भारत सरकार  
Government of India  
विद्युत मंत्रालय  
Ministry of Power  
उत्तर क्षेत्रीय विद्युत समिति  
Northern Regional Power Committee

**विषय:** संरक्षण उप-समिति की 45<sup>वीं</sup> बैठक के कार्यवृत्त।  
**Subject:** Minutes of 45<sup>th</sup> Protection Sub-Committee Meeting.

## ***Minutes of 45<sup>th</sup> Meeting of Protection Sub-committee***

## Points for discussion to be taken up in 45<sup>th</sup> PSC

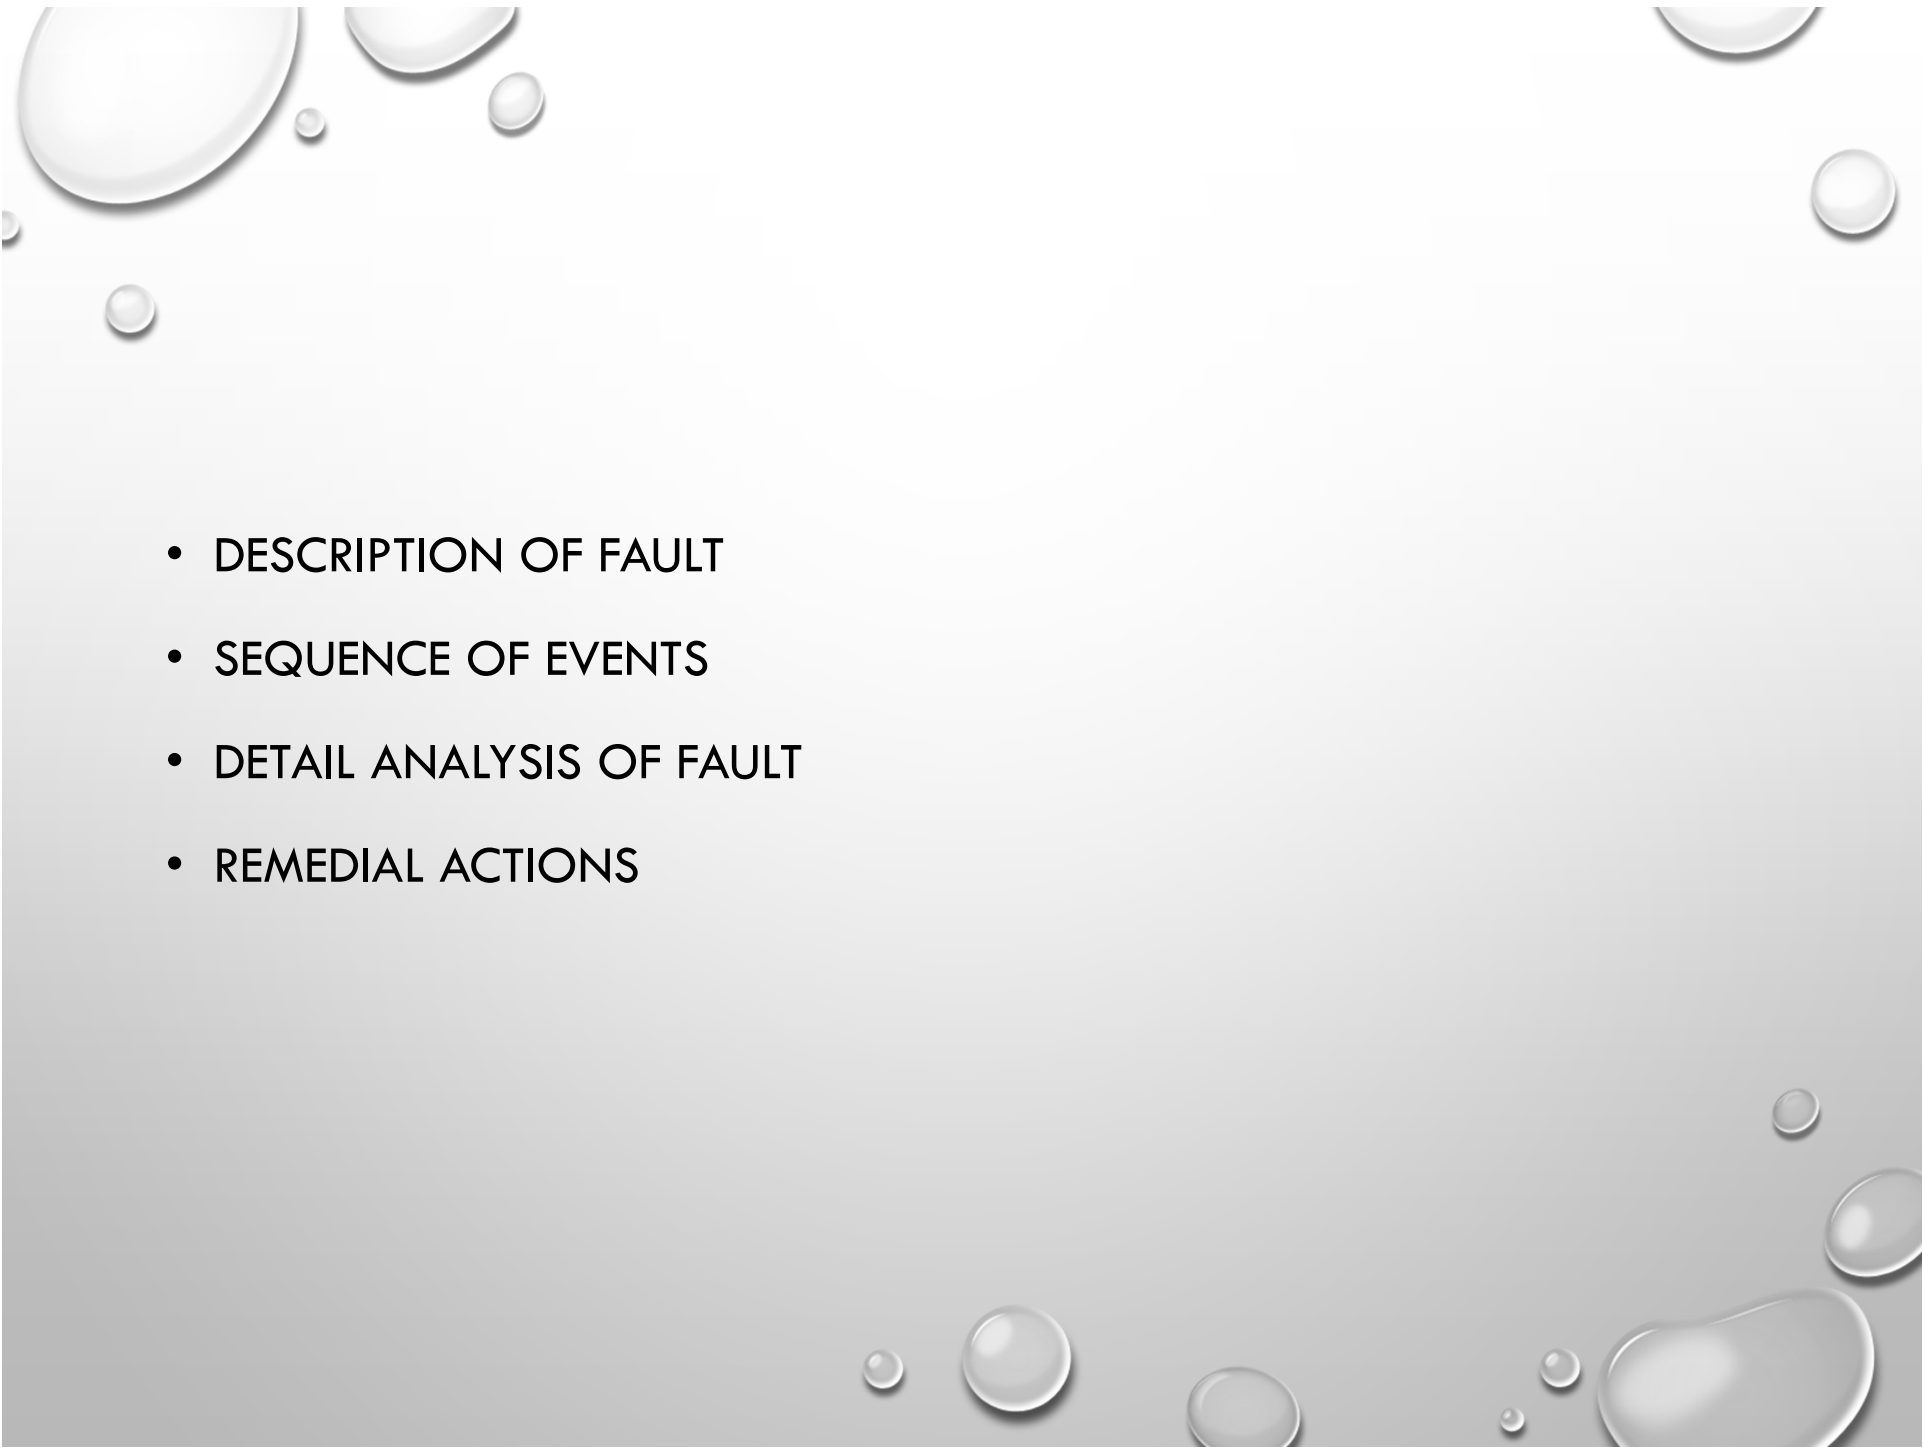
- Why did bus bar protection of Bus 1 operate(as fault was in ICT3 which was connected to bus 2).
- R phase CT of ICT3 blasted and its flame touched the transfer bus (Bus Reactor was charged through it) and Transfer bus was charged through Bus 1 thus ZONE1 & ZONE3 of Bus Bar Protection operated.

- Reason of delayed clearance of fault.
- As per DR of 400 KV Muzaffarnagar-Alaknanda, At 400 KV Muzaffarnagar fault occurred at 03:02:38.615 and fault was cleared at 03:02:38.695 (fault cleared within 70 to 80 ms. approx.) for ICT-3 fault was cleared within 40ms on differential protection and bus fault was cleared within 60ms as per DR.

# Observations

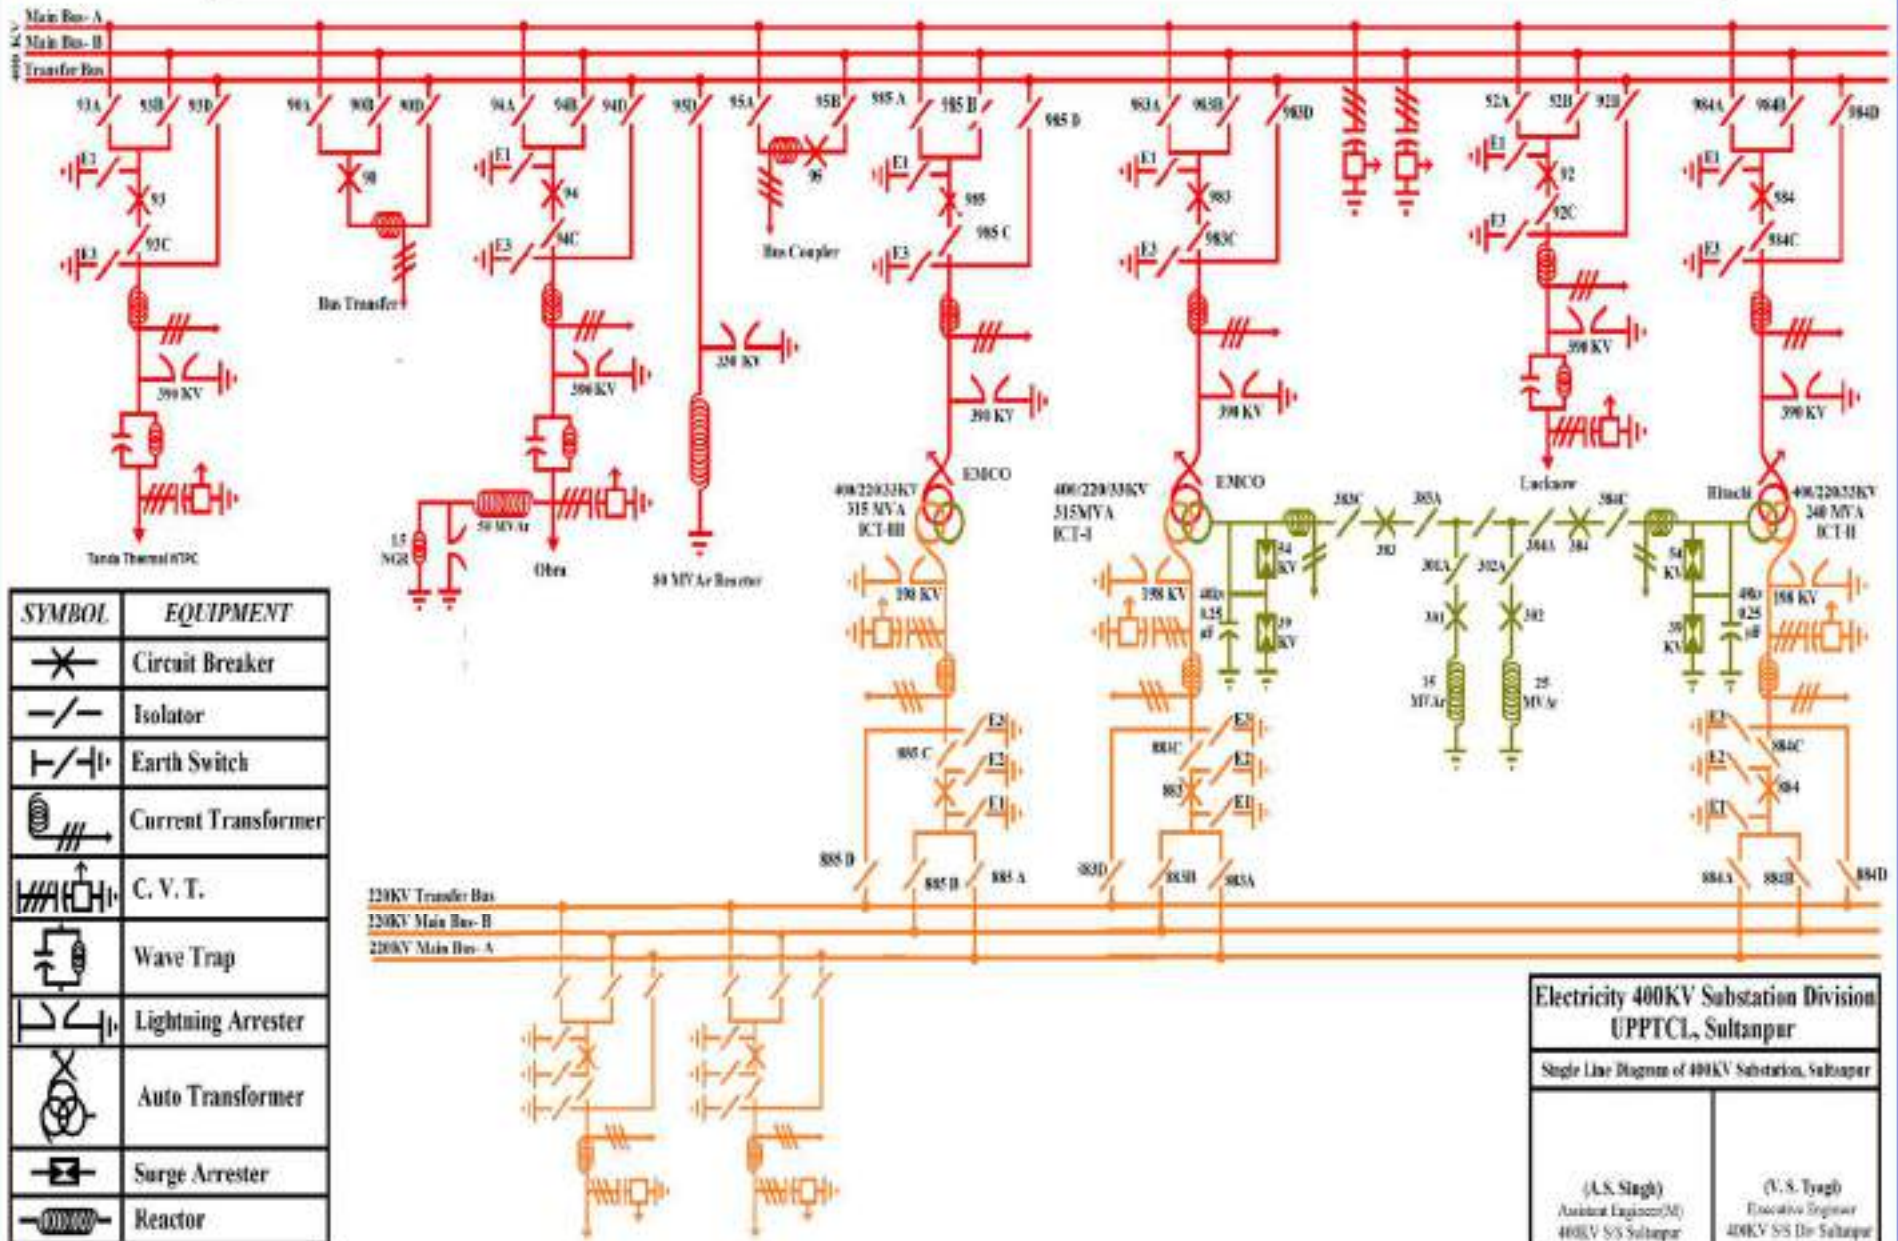
1. As per DR 400kV Sultanupr-Lucknow line tripped on SOTF operation then why did fault persist later also?
2. Why delayed fault clearance is there?
3. Did busbar protection trip at Sultanpur?
